MEMORANDUM

SUBJECT: BZA #19808 – 1740 40th Street, SE
 BZA #19809 – 1736 40th Street, SE
 Requests to permit vehicle parking partially in the front yard

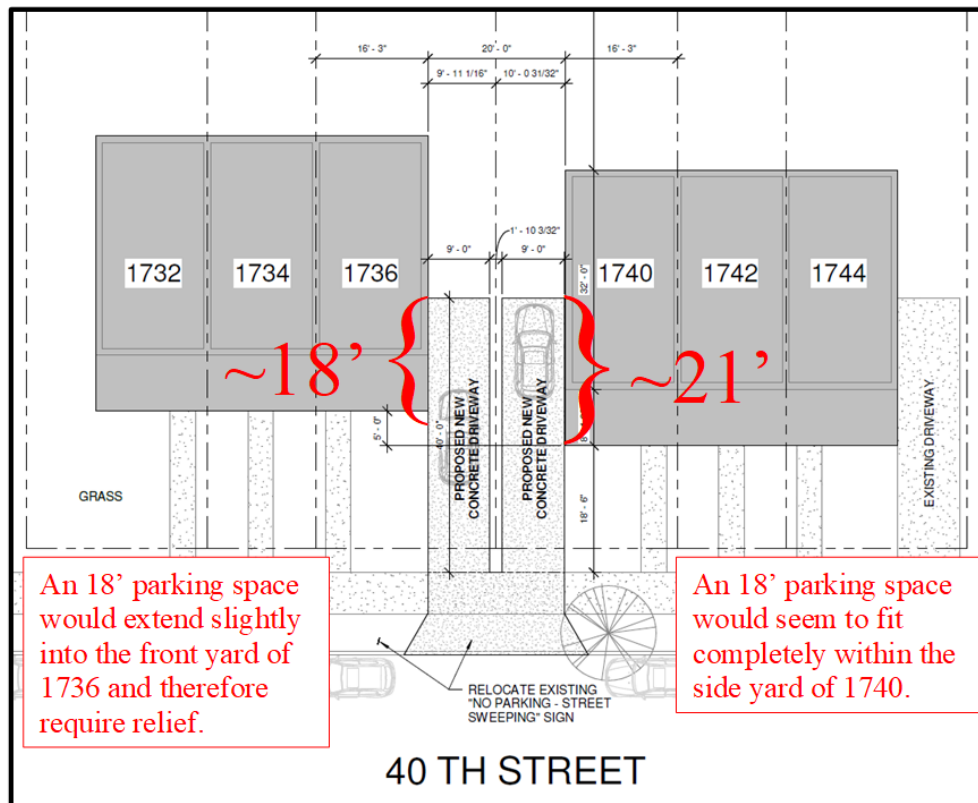
A conforming parking space is nine feet wide by 18 feet deep. While it appears that the parking space for 1736 40th Street would be about two or three feet into the front yard, it appears from the plat that the parking space for 1740 would be entirely in the side yard. See the image below, which was modified from an excerpt from Exhibit 7 of case 19808.

Image showing the rear slope of the subject properties, with the alley in the foreground.

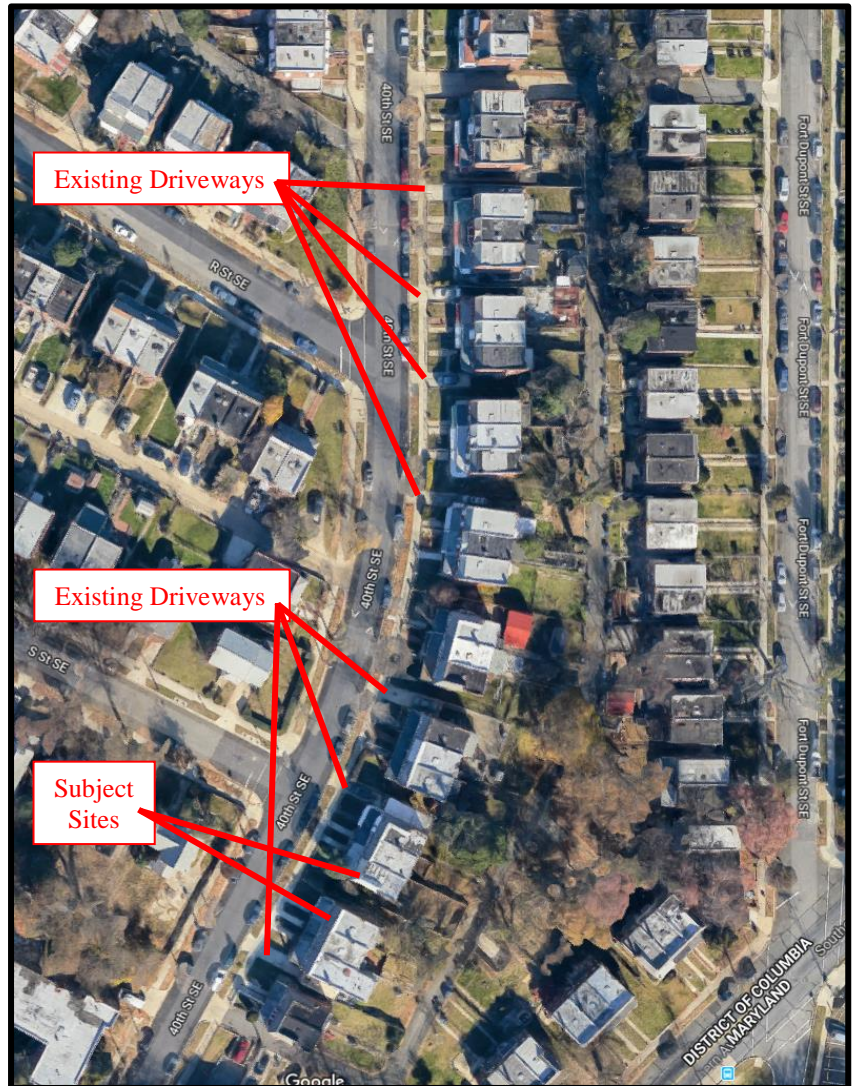
The subject property is impacted by an exceptional slope at the rear of the lot, the portion adjacent to the alley. According to the applicants' statements, and supported by the photographs in the records, the lots drop approximately 30 feet in elevation from the front of the properties to the rear, with the steepest portion being immediately adjacent to the alley. This topographical condition would create a practical difficulty for the property owners if they elected to locate a parking space at the rear of their lots. Excavation and retaining walls would be difficult and expensive to execute and install. It would also likely mean the loss of at least two large, mature trees at the rear of 1740.
